# Service Bulletin

**Subject:** Steam/Vapor Coming from Front Grille or Radiator Area, Engine Runs Rough or Stalls, DTC P0506 Set

**Models:** 2014 Chevrolet Impala (VIN 1)

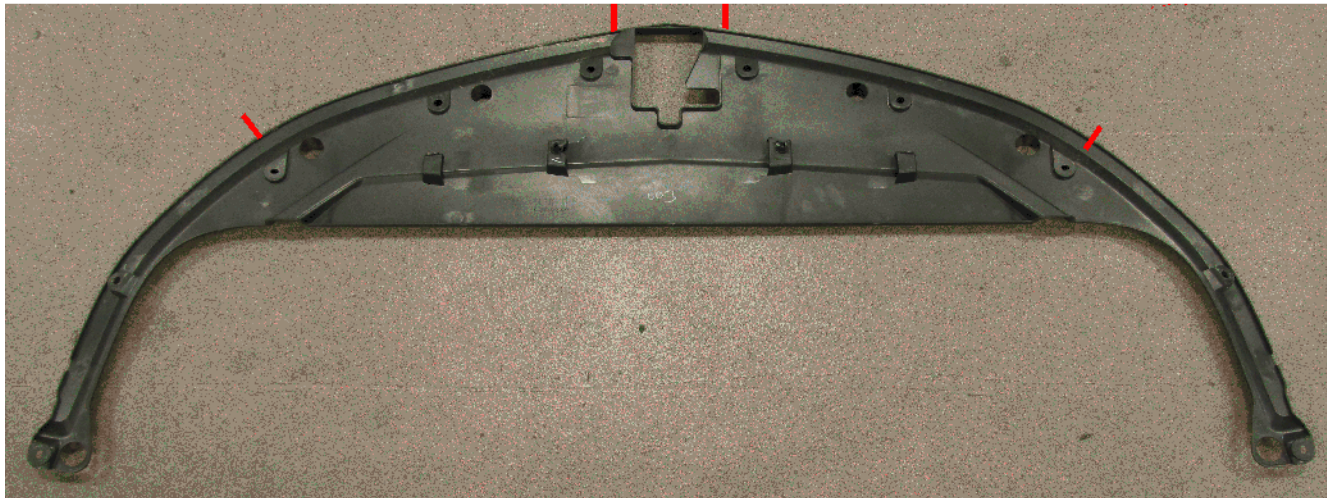
Some customers may comment that after going through a car wash, the vehicle runs rough or engine stalls and may illuminate the MIL and have set DTC P0506.

This condition may be caused by water vapor getting ingested into the induction system through the air intake that is located behind the grille.

Apply BRS tape to the front compartment front sight shield front lip and replace the radiator air upper baffle and deflector following the procedure below.

2. Cut two pieces of BRS tape 425 mm (17 in) and peel the backing off. Place the adhesive side along the marked area on the front sight shield front lip as shown in the illustration above.
3. Replace the radiator air upper baffle and deflector with the revised part number listed below. Refer to Radiator Air Upper Baffle and Deflector Replacement in SI.
